F28M36x Concerto™ MCUs Silicon Errata

Silicon Revisions F, E, B, A, 0

This document describes the silicon updates to the functional specifications for the F28M36x microcontrollers (MCUs).

Figure 8. Placement of Series Termination Resistor and Pullup Resistor

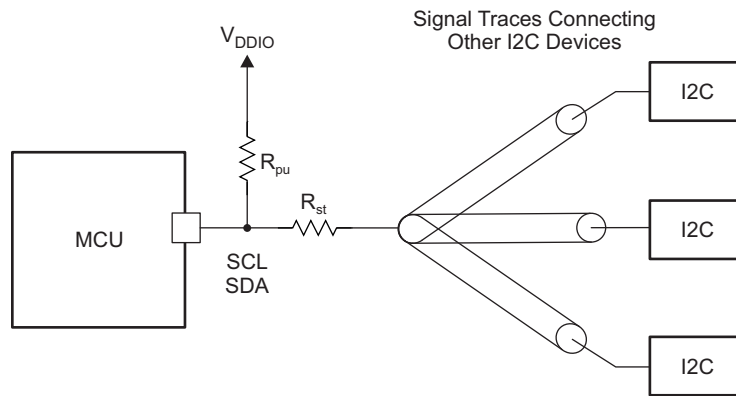
Advisory
Master Subsystem I2C: SDA and SCL Open-Drain Output Buffer Issue
Revision(s) Affected

The SDA and SCL outputs are implemented with push-pull 3-state output buffers rather than open-drain output buffers as required by I2C. While it is possible for the push-pull 3-state output buffers to behave as open-drain outputs, an internal timing skew issue causes the outputs to drive a logic-high for a duration of 0–5 ns before the outputs are disabled. The unexpected high-level pulse will only occur when the SCL or SDA outputs transition from a driven low state to a high-impedance state and there is sufficient internal timing skew on the respective I2C output.

This short high-level pulse injects energy in the I2C signals traces, which causes the I2C signals to sustain a period of ringing as a result of multiple transmission line reflections. This ringing should not cause an issue on the SDA signal because it only occurs at times when SDA is expected to be changing logic levels and the ringing will have time to damp before data is latched by the receiving device. The ringing may have enough amplitude to cross the SCL input buffer switching threshold several times during the first few nanoseconds of this ringing period, which may cause clock glitches. This ringing should not cause a problem if the amplitude is damped within the first 50 ns because I2C devices are required to filter their SCL inputs to remove clock glitches. Therefore, it is important to design the PCB signal traces to limit the duration of the ringing to less than 50 ns. One possible solution is to insert series termination resistors near the SCL and SDA terminals to attenuate transmission line reflections.

Insert series termination resistors on the SCL and SDA signals and locate them near the SCL and SDA terminals. The SCL and SDA pullup resistors should also be located near the SCL and SDA terminals. The placement of the series termination resistor and pullup resistor should be connected as shown in [Figure 8](#).

Table 6 provides series termination and pullup resistor value recommendations. The I2C signal level and respective V_{DDIO} power supply voltage is shown in the first column. Two resistor value combination options are provided for each voltage. One option supports a maximum high-level input current of 200 μ A to all attached I2C devices, while the other option supports a maximum high-level input current of 100 μ A to all attached I2C devices.
